City of Detroit  
Inter-Departmental Communication

**RE:** Petition No. 1664  
Request to Convert To Easement The North/South Alley In The Block Bound By  
Parkside, Midland, Alden Ave., And John C. Lodge Freeway

**NOTICE OF PROPOSED CHANGE IN PROPERTY**

**REQUEST TO VACATE TO EASEMENT  
 THE NORTH/SOUTH PUBLIC ALLEY, 15 FT. WD.  
 IN THE BLOCK BOUND BY  
 PARKSIDE, MIDLAND, ALDEN AVE.  
 AND JOHN C. LODGE FWY.**

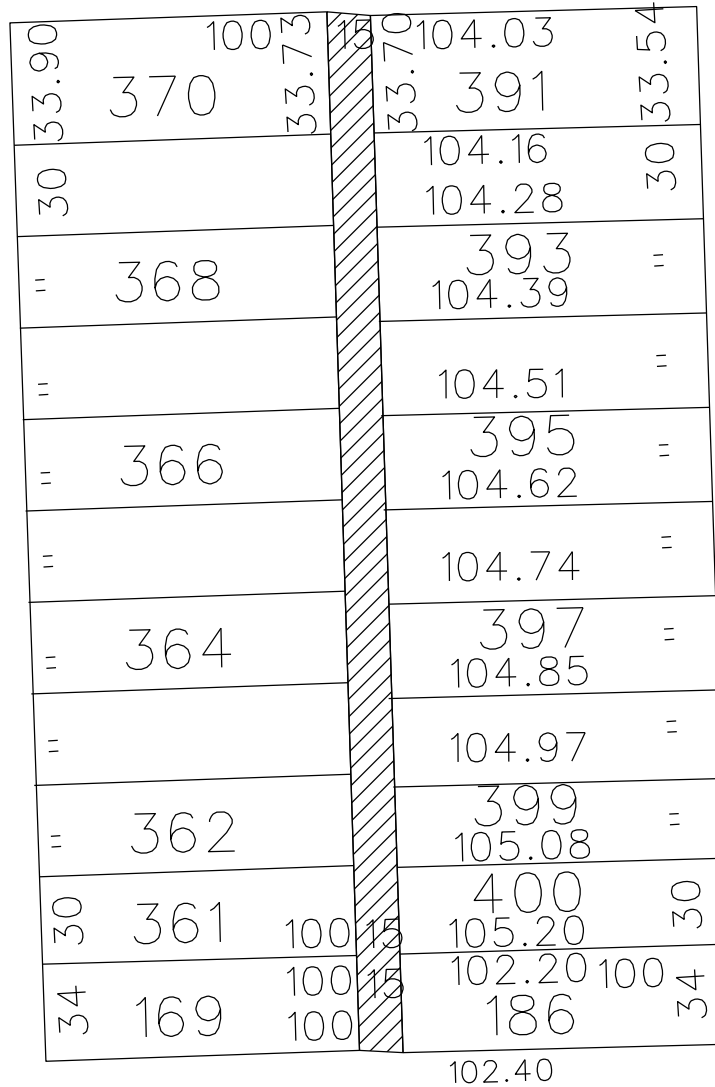
- Our records indicate that there is sewer in the alley. DWSD has no objection to the requested conversion to easement provided that the attached provisions for conversion to easement are strictly followed.
